VERAMENDI SECTOR PLAN 1A

STREET LAYOUT

PROPOSED
AMENDMENT
- MARCH 5, 2019

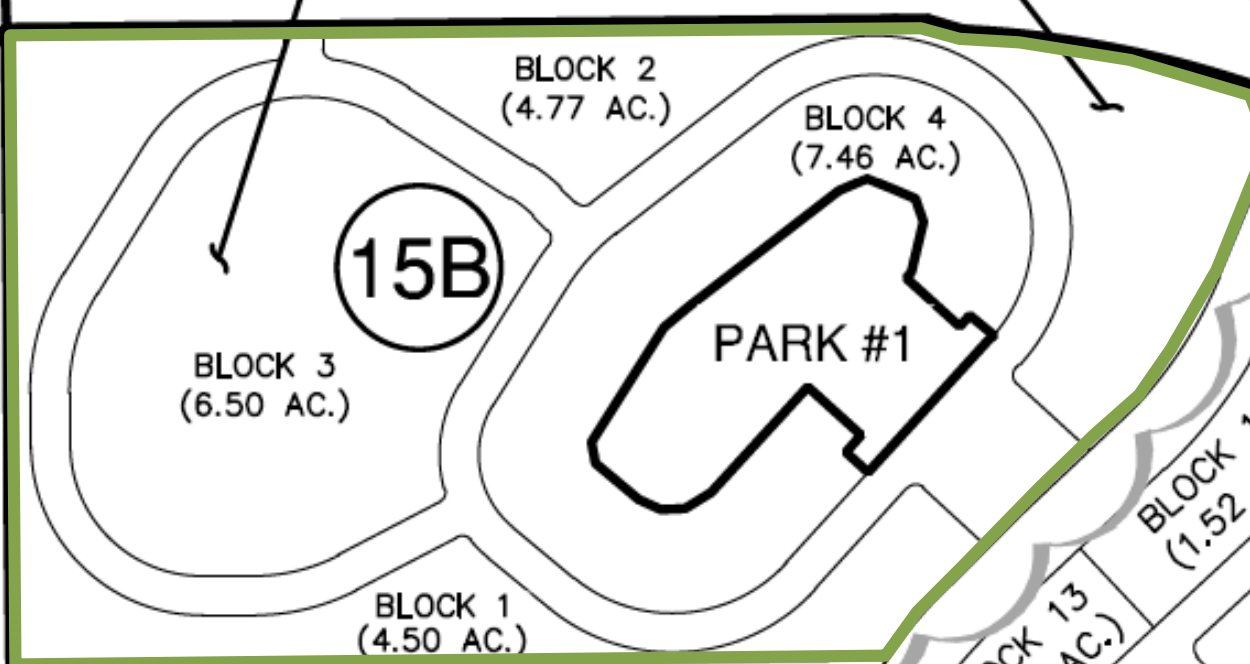
Allows for more open space, tree preservation, and flow of traffic

LOT LAYOUT & DENSITY

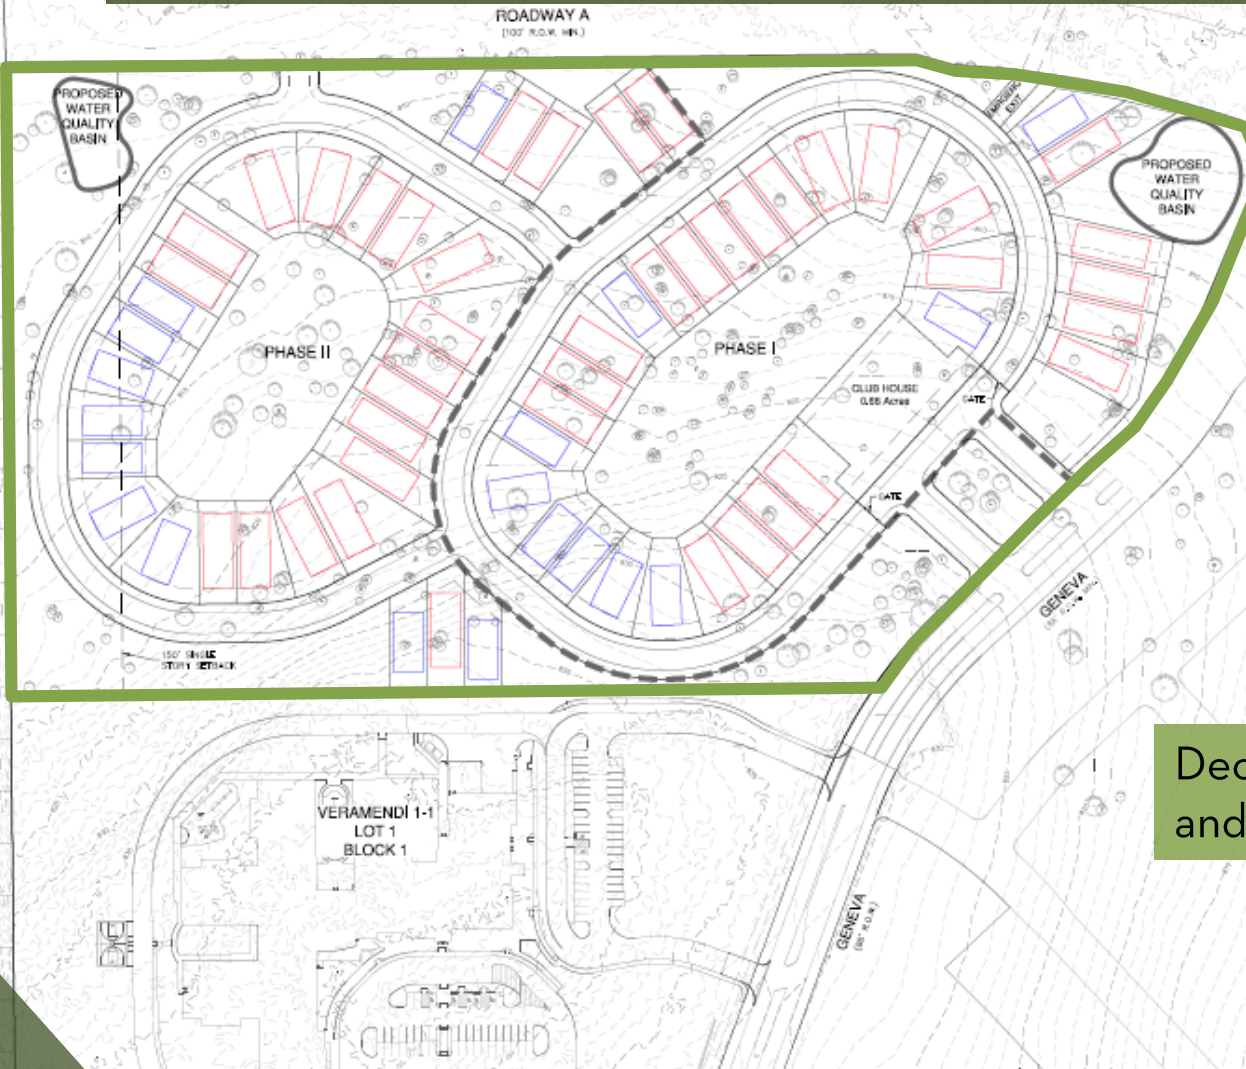
Proposed 115 lots of 50'x120'

Decrease to 61 proposed lots
and decrease in density
